Re: Responses to Planning Board Consultant Comments
Buttermilk Falls
Town of Marlborough, New York

As requested, I am providing my responses to comments made by Planning Board Consultant Creighton Manning (CM) in a letter dated January 26, 2024.

FIGURE 10

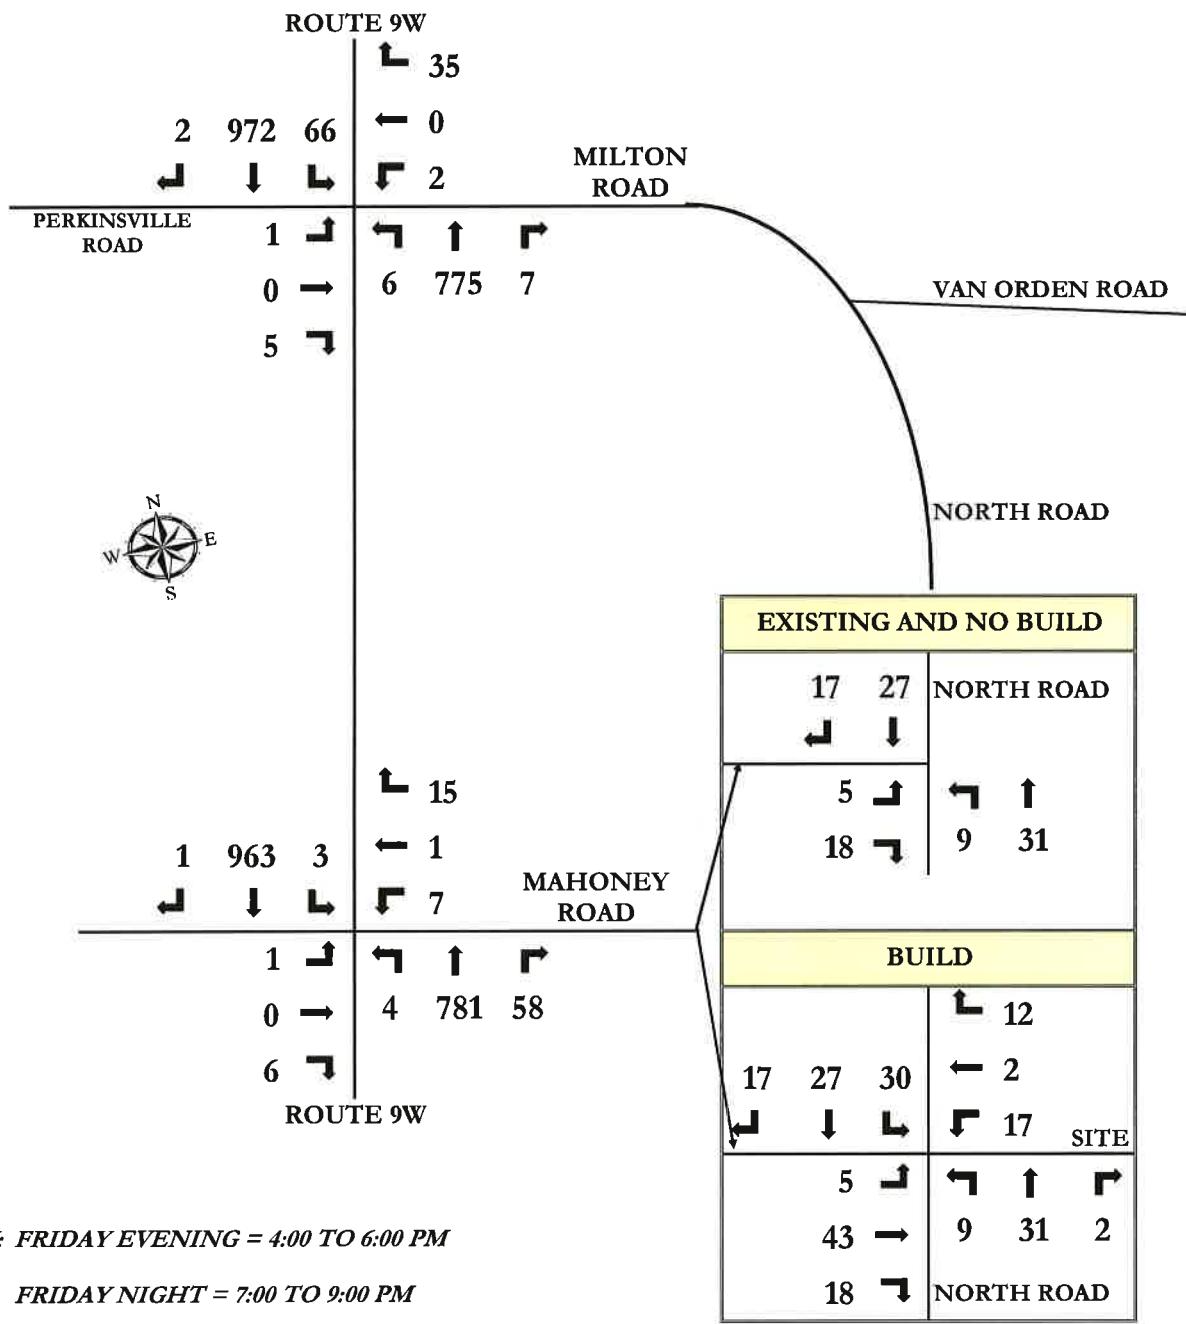
1. Discuss the anticipated frequency of large events at the site.
2. Provide a sensitivity analysis of conditions that may result should there be an overlap of use at the larger seating facilities.
3. The departure traffic could use North Road to Milton Turnpike and turn left onto Route 9W instead of the much more difficult left turn from Mahoney Road onto southbound Route 9W.

2. A sensitivity analysis was conducted that assumed some overlapping of events, and to include the larger venue on the site. The sensitivity scenario for a Friday evening/night included the following trip generators:

- a. Full occupancy at the hotel
 - b. Fine dining restaurant is open
 - c. A nighttime event at the banquet hall for 300 guests, of which half arrive during the Friday evening peak hour of the adjacent streets.

The trips noted above were distributed to the Route 9W intersections similar to the pattern used in the original study – with one exception. As suggested by CM, traffic departing the site that was distributed to Mahoney Road in order to turn left onto southbound Route 9W could instead simply turn left out of the site onto North Road and then use Milton Turnpike and the traffic signal at Route 9W to turn left. Directional signs at the site exits will be added to encourage departing traffic to use that alternate route.

The resulting Friday Evening traffic volumes are shown in the attached Figure as are the resulting Level of Service analysis summaries for Route 9W at Milton Road and at Mahoney Road. Conditions would be marginally acceptable at Mahoney Road for that time period under a scenario with an overlapping large event. At all other times, conditions would be acceptable. The impacts of the sensitivity scenario would be minimal.
